FORM 9
CERTIFICATE OF SUBSTANTIAL PERFORMANCE OF THE
CONTRACT UNDER SECTION 32 OF THE ACT

Reconstruction of Algonquin Blvd. W. - Contract #2021-207

RECONSTRUCTION OF ALGONQUIN BLVD (MATTAGAMI BRIDGE TO THERIAULT BLVD)

CONTRACT # 2021-207

WATER SERVICE "MAIN STOP" WITH ELECTRICAL THAW CONNECTION

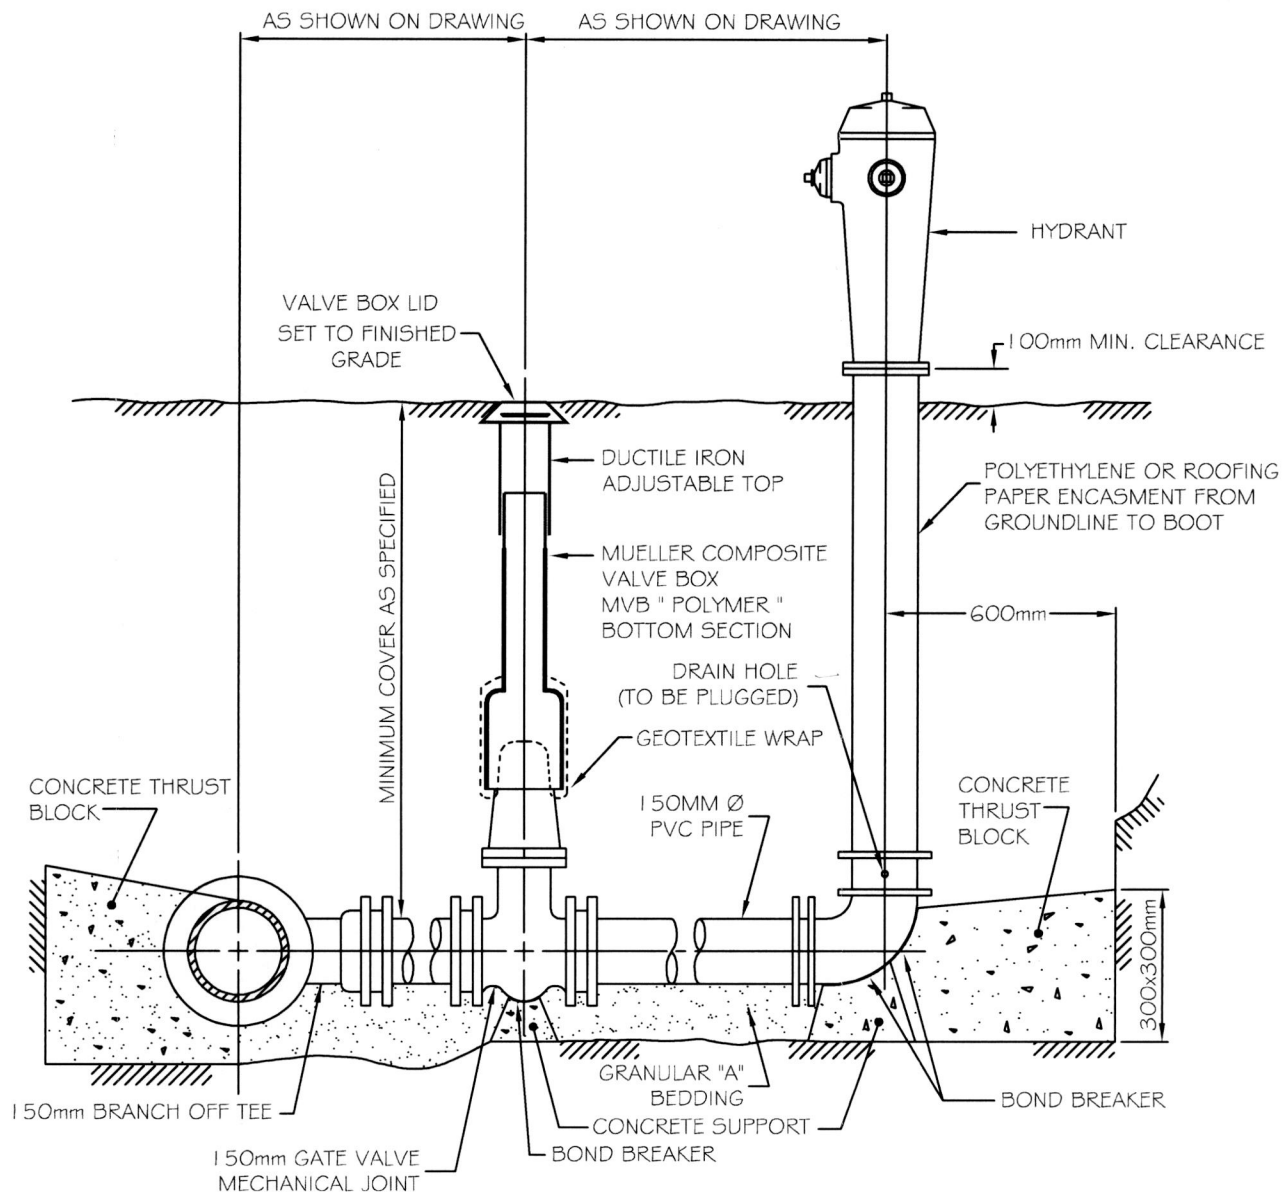
No.	Deficiency	Status	Action By	COST
1	Remaining Topsoil & Sod areas: East side of Charles St and City Park, back of SWK @ NE Theriault Intersection & Vital Air.	INCOMPLETE	BELANGER CONSTRUCTION	\$6,200
2	Re-Install Guy Wire @ Cloutier & Wilson, including restoration.	INCOMPLETE	BELANGER CONSTRUCTION	\$5,000
3	Vianet 19mm Water Service, Thaw Wire to be exposed and finished as per attached DWG 411	INCOMPLETE	BELANGER CONSTRUCTION	\$2,390
4	Caffeination 19mm Water Service, Thaw Wire to be exposed and finished as per attached DWG 411	INCOMPLETE	BELANGER CONSTRUCTION	\$2,390
5	Hydrant @ Fogg St S to be raised out of asphalt as per attached DWG 420	INCOMPLETE	BELANGER CONSTRUCTION	\$2,000
6	Attenuator Barrel Missing Lid	INCOMPLETE	BELANGER CONSTRUCTION	\$1,000
7	Granular A to protect edge of asphalt @ North 16+595 to 16+610.	INCOMPLETE	BELANGER CONSTRUCTION	\$1,000
8	38mm Water Service @ 16+605, Thaw Wire to be exposed and finished as per attached DWG 411	INCOMPLETE	BELANGER CONSTRUCTION	\$2,470

9	Shack a Patate 19mm Water Service, Thaw Wire to be exposed and finished as per attached DWG 411	INCOMPLETE	BELANGER CONSTRUCTION	\$2,390
10	Grade and pave gravel patch in front of Pawn Shop building.	INCOMPLETE	BELANGER CONSTRUCTION	\$1,000
11	Pawn Shop 19mm Water Service, Thaw Wire to be exposed and finished as per attached DWG 411	INCOMPLETE	BELANGER CONSTRUCTION	\$2,390
12	Lil Bit Western 19mm Water Service, Thaw Wire to be exposed and finished as per attached DWG 411	INCOMPLETE	BELANGER CONSTRUCTION	\$2,390

13	Hydrant 4 Valve in Blvd. lower valve lid	INCOMPLETE	BELANGER CONSTRUCTION	\$2,000
14	Lil Bit Western 25mm Water Service & Thaw Wire to be exposed and finished as per attached DWG 411	INCOMPLETE	BELANGER CONSTRUCTION	\$1,685
15	CB10 & CBMH9 to be lowered and Asphalt to be removed and repaved to make gutter line run into CB's	INCOMPLETE	BELANGER CONSTRUCTION	\$22,000
16	Hydrant 5 to be raised out of asphalt as per attached DWG 420	INCOMPLETE	BELANGER CONSTRUCTION	\$2,000
17	Western Auto Sales 19mm Water Service Cap cut off. Thaw Wire to be exposed and finished as per attached DWG 411	INCOMPLETE	BELANGER CONSTRUCTION	\$2,390
18	CB12 to be lowered, remove and repave asphalt to have gutter line run into CB.	INCOMPLETE	BELANGER CONSTRUCTION	\$11,000
19	MH111 to be cleaned out and properly benched as per OPSD 701.021	INCOMPLETE	BELANGER CONSTRUCTION	\$5,000
20	#26 Charles St Driveway to be properly graded	INCOMPLETE	BELANGER CONSTRUCTION	\$1,000
